PRODUCT / PROCESS CHANGE NOTIFICATION

1.1 Company		STMicroelectronics International N.V
1.2 PCN No.	EMBEDDED PROCESSING/26/16419	
1.3 Title of PCN	Amkor ATJ (Japan) additional assembly line for STM32H74x & STM32H75x listed products in LQFP20x20 and LQFP14x14 packages	
1.4 Product Category	STM32H742x, STM32H743x, STM32H750 and STM32H753x.	
1.5 Issue date	2026-07-09

PCN16419 – Additional information

Amkor ATJ (Japan) additional assembly line for STM32H74x and STM32H75x listed products in LQFP 20x20 and LQFP 14x14 packages.

The standard marking fields example below
for **LQFP 144L 20x20** package

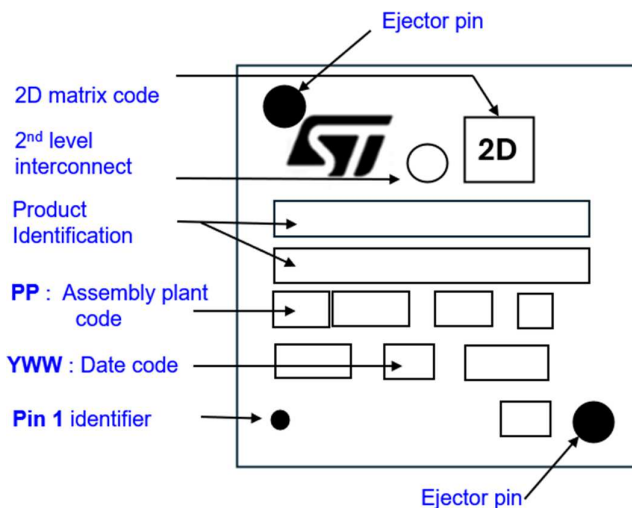
How can the change be seen?

Pin1 identifier may change in terms of size and positioning however remaining near pin1's edge.
Marking position and size may be different upon assembly site, without any loss of information.

Table 2: Marking Example with Commercial product

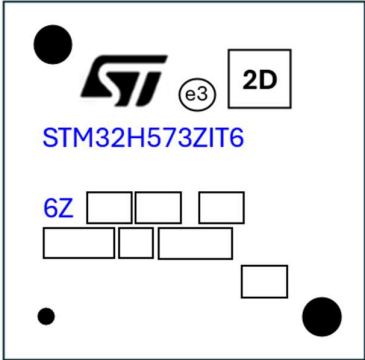
Package example	Amkor ATJ (Japan)
LQFP 14x14 100L (ie: STM32H743VGT6)	 The diagram shows a square package with a grid of pins. Markings include the ST logo, a circled 'e3', a '2D' box, the part number 'STM32H743VGT' in blue, and the suffix '6' in blue. There are also '6Z' and several empty boxes for additional markings.
LQFP 20x20 144L (ie: STM32H742ZIT6)	 The diagram shows a square package with a grid of pins. Markings include the ST logo, a circled 'e3', a '2D' box, the part number 'STM32H573ZIT6' in blue, and the suffix '6' in blue. There are also '6Z' and several empty boxes for additional markings. Two large black circles are present at the top-left and bottom-right corners of the package area.
